REPORT TO COUNCIL

DP12-0029

3151-3155 Lakeshore Road

To approve the Form and Character of the proposed two storey commercial development.

A102 Drawing SITE PLAN - PARTIAL AND ZONING

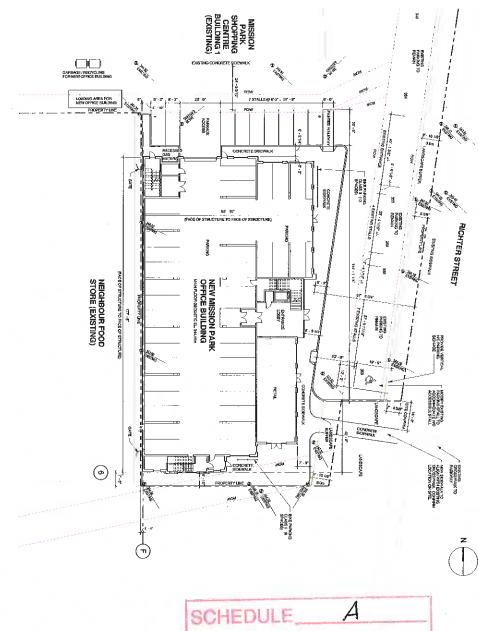
- (a) A parking requirement review is required.
- (b) Indicate on the Site Plan, the locations of loading bays as well as the garbage and recycle bins.
- (c) Provide a Lot Grading and Storm Management Plan
